Turbo HD DVR V4.24.001build 191225 Release Notes (2020-01-02)

Reason of Upgrade

Main update

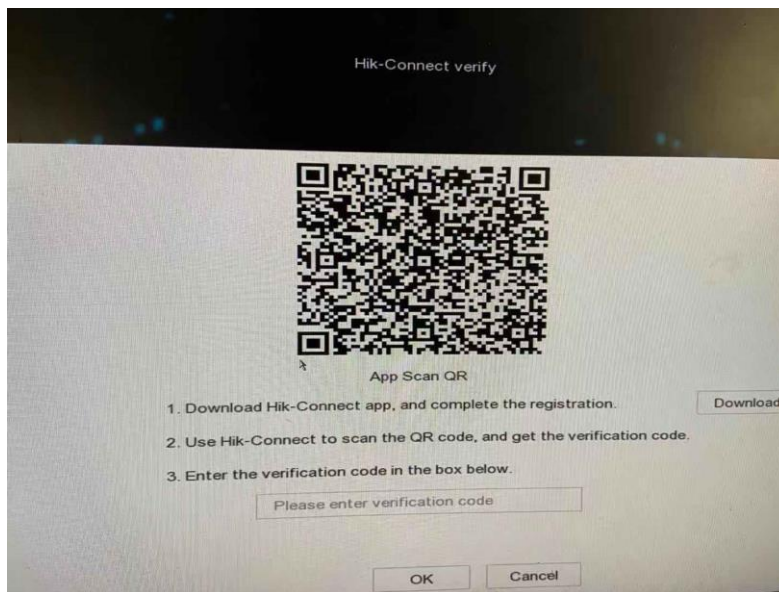
- Released new HUH-M/FA models. The Brazil、Russia、 Europe versions are released in sync with baseline .
- The all M-series models support coaxial audio.
- Newly support to recover device password via Hik-Connect.
 - 1) Choose Verify by Hik-Connect

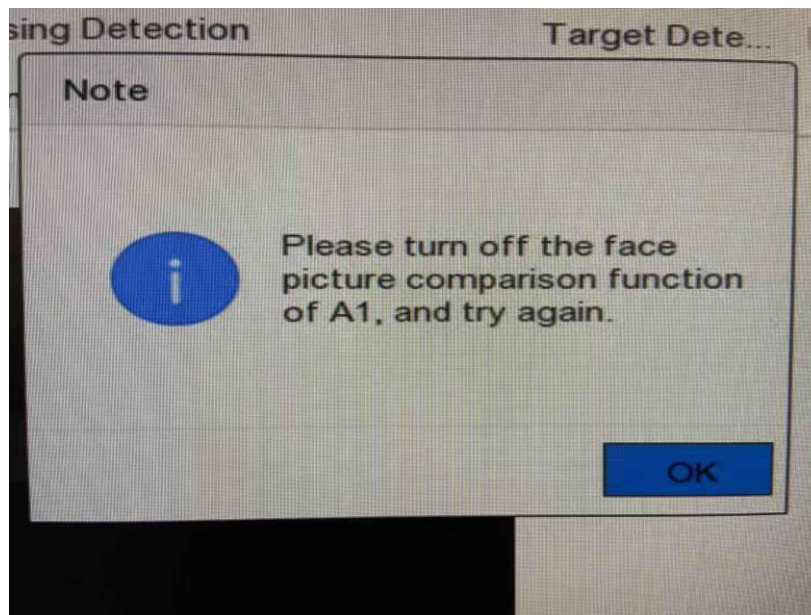
- 2) Use Hik-Connect to scan the QR code, get and enter the verification code .
